SUBJECT: Proposed Use of Alma-Summerton Future Double Circuit Structures
Reference No: Chippewa Township/Isabella County/Lott

REFERENCE: Amended and Restated Easement Agreement (the "Agreement") dated April 29, 2002, between Consumers Energy Company ("Consumers") and Michigan Electric Transmission Company, now Michigan Electric Transmission Company, LLC ("METC")

CONSUMERS ENERGY
NOTIFICATION OF PROPOSED LINE CONSTRUCTION
REQUIRING COORDINATION WITH TRANSMISSION LINES

APPROVED RG COTTRELL DATE 9-30-99 Dwg No. TL0019202-E Rev G Sh 1

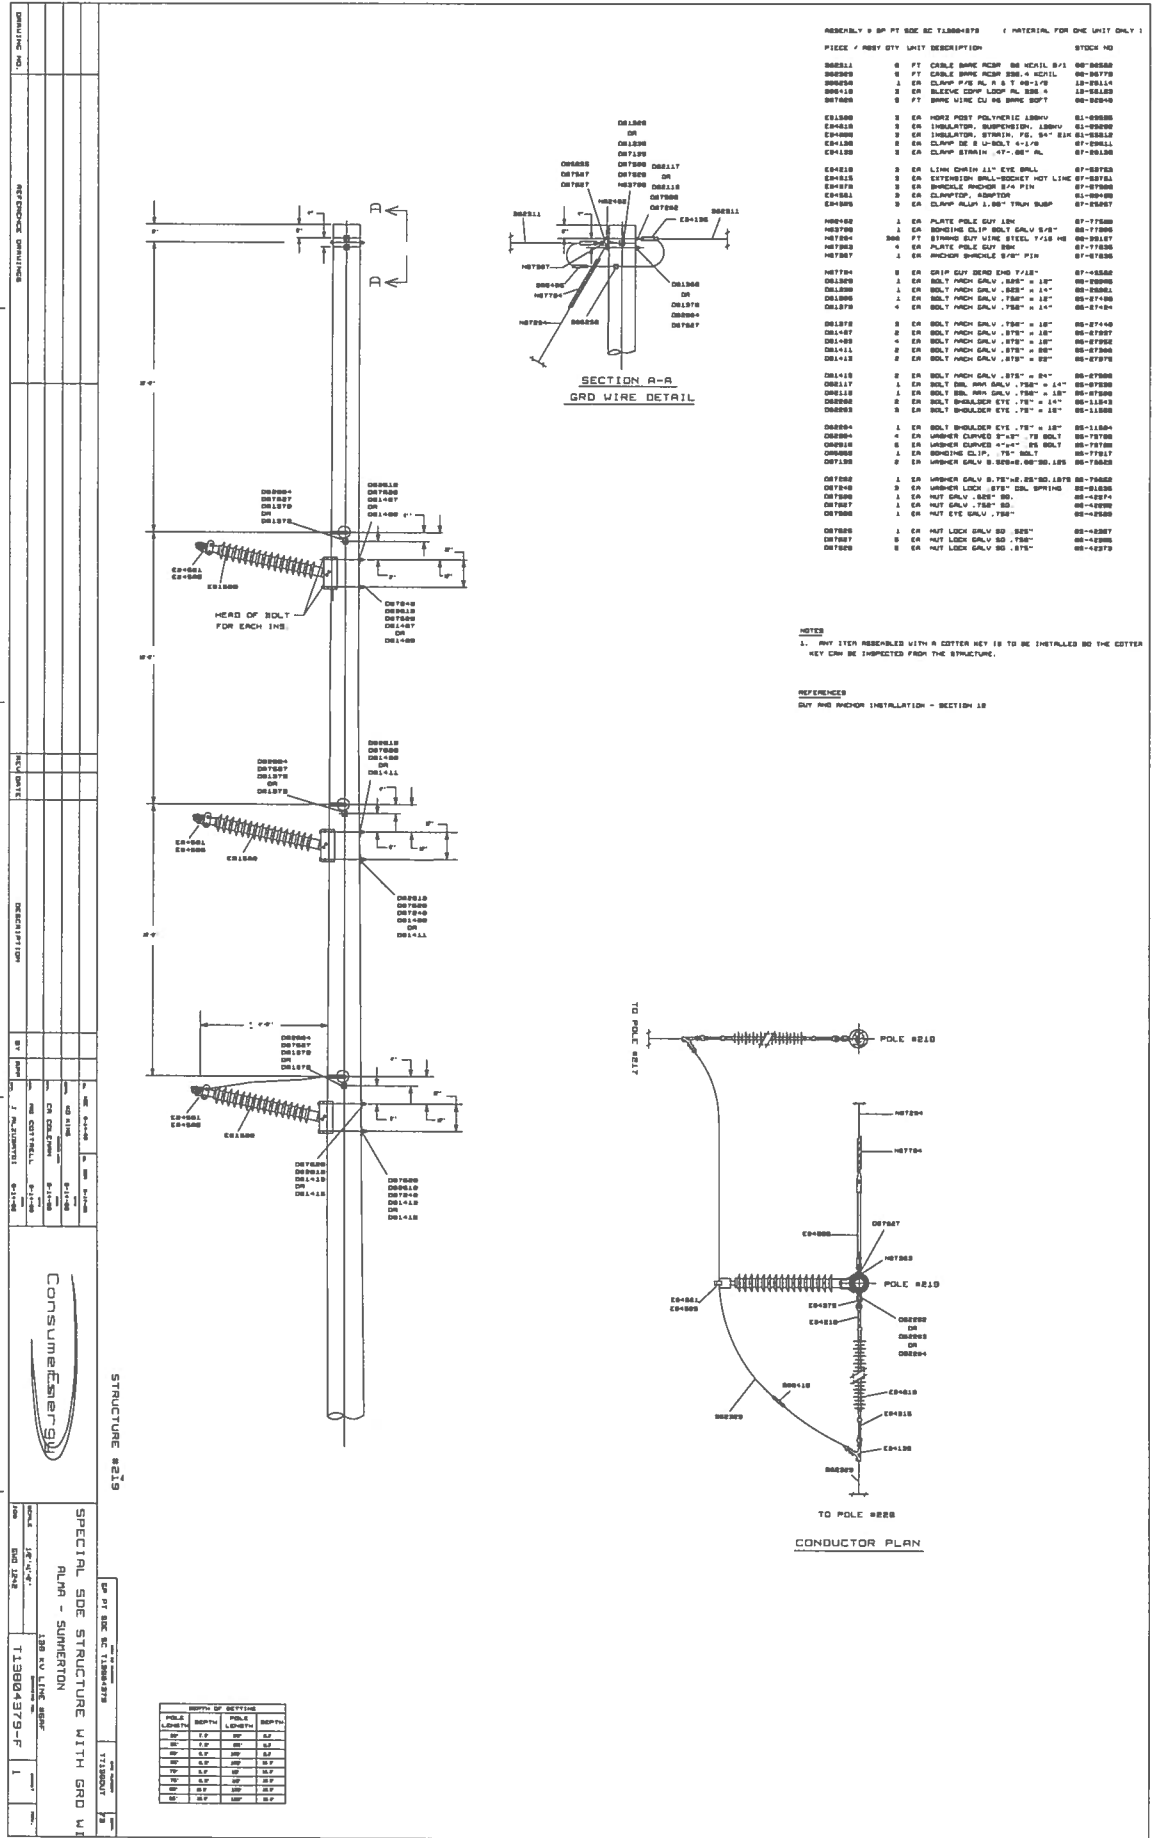
This line was designed for a double circuit of witch METC only has one currently installed. Therefore, we have nothing to check at this time and it becomes a planning issue. If you should have any questions do not hesitate to call.
